MFN 10-044 Supplement 3

**Revised Response (Revision 3) to NRC Request for
Additional Information Letter No. 411
Related to ESBWR Design Certification Application**

RAI Number 6.2-202 S01

**NEDO-33572, "ESBWR ICS and PCCS Condenser
Combustible Gas Mitigation and Structural Evaluation,"
Revision 3, September 2010**

Figure 3: Conceptual Design for In-Line Catalyst

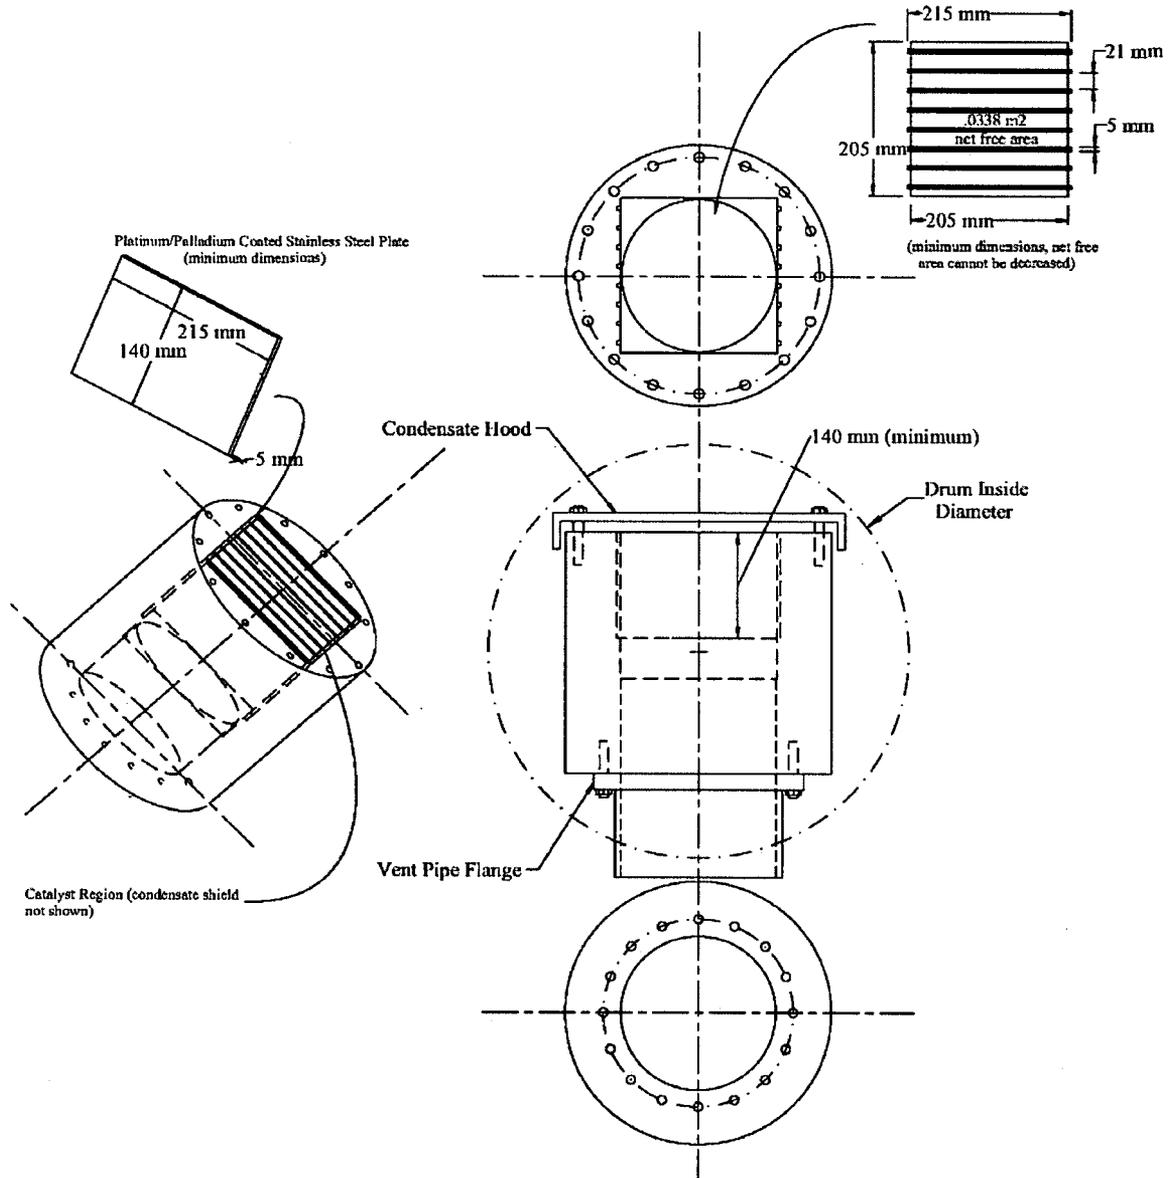
This catalyst configuration as depicted in Figure 3, was based on the design attributes (plate dimensions, spacing, etc.) of a similar catalyst that underwent extensive performance testing.

Figure A-1b: PCCS Condenser and Supports Details

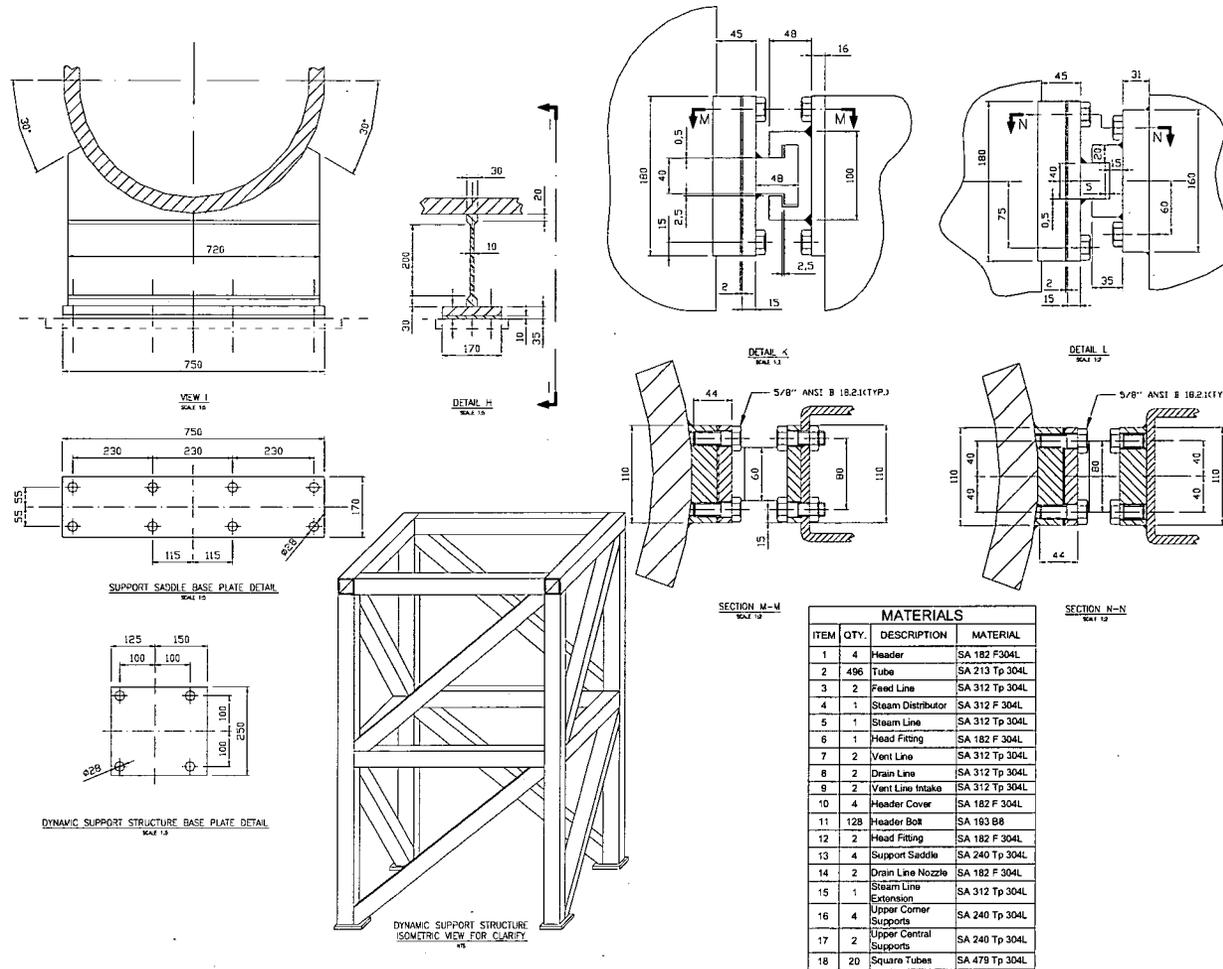
Table of materials for the PCCS as shown in Figure A-1b has been reproduced with updated material changes in Figure B-2a of Appendix B.

Figure B-2a: PCCS Condenser and Supports Details

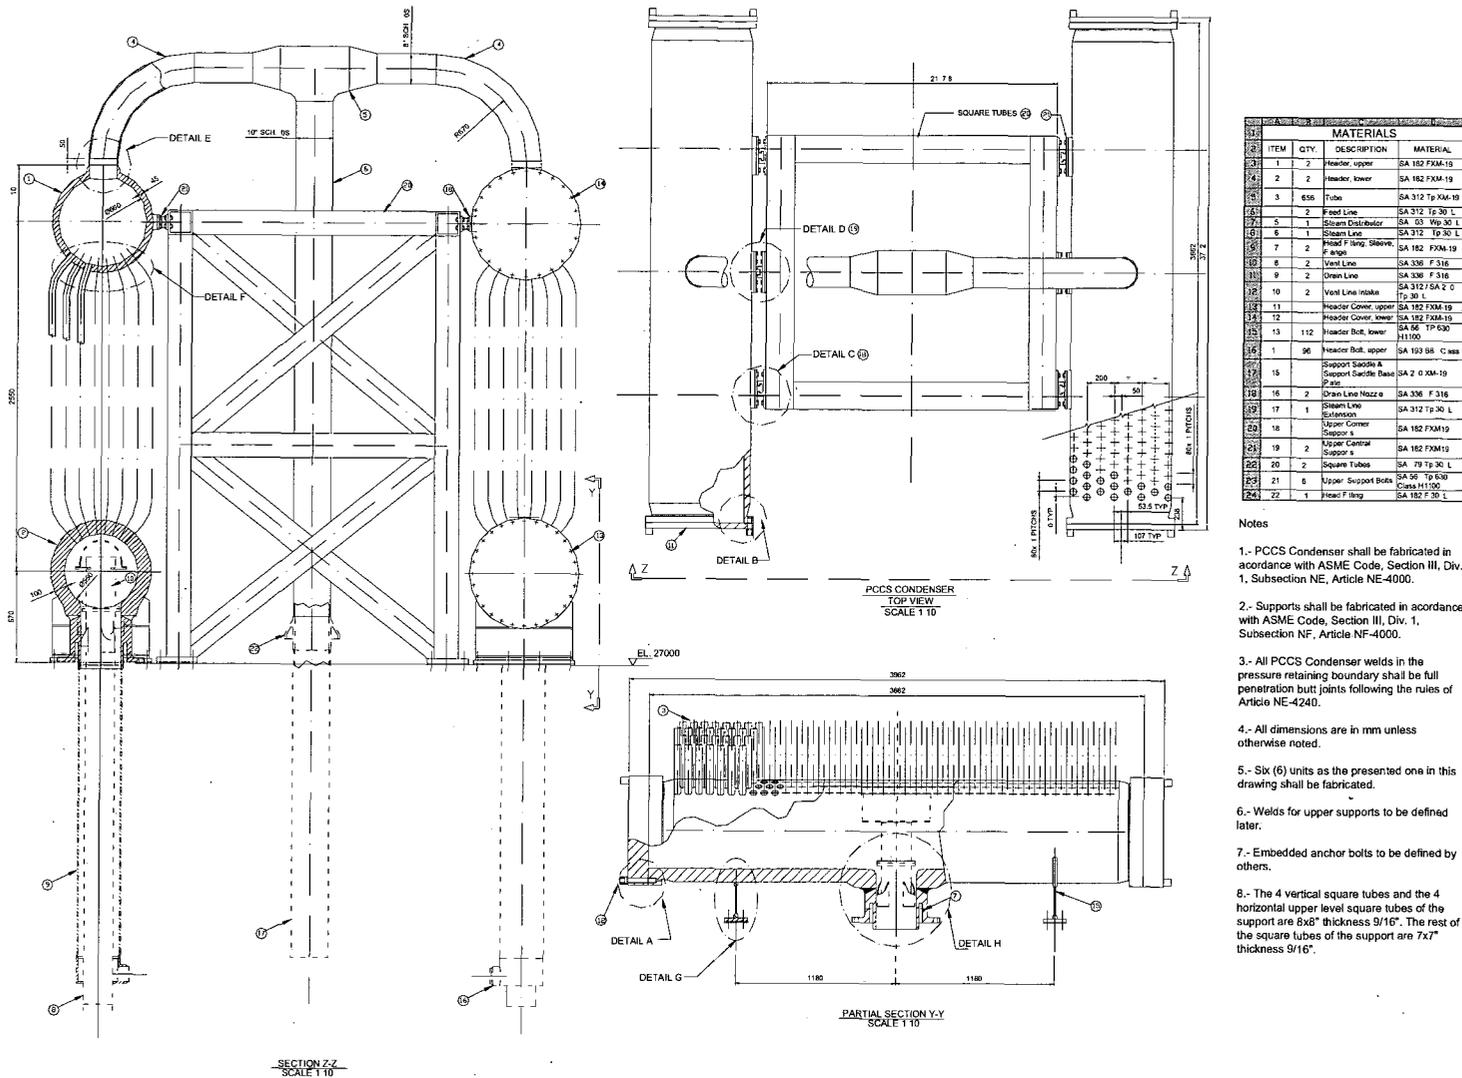
- PCCS drum material changed to SA182 FXM-19 (both upper and lower drums).
- Thickness of lower drum increased to [[]] (upper drum thickness remains[[]]).
- Catalyst module added to the entrance of the vent in the lower drum of the condenser.
- Ball valve is added to the vent fan branch line upstream of the fan. Check valve has been removed from the design.
- Vent line between the branch for the vent fans and the suppression pool is reduced to a nominal size of 3”.
- Lower drum covers increased to a thickness of [[]].
- Increased sizes for the square tubes of the supporting structure. See Appendix B, Figure B-2a, Note 8 for exact sizes.
- Condensate drain line nozzle and flange. See Appendix B, Figure B-2b for dimensions.

For the PCCS, there are no dissimilar metal welds. XM-19 to 304L or to 316 is not considered a dissimilar metal weld. PCCS materials are listed in Figure B-2a of Appendix B.
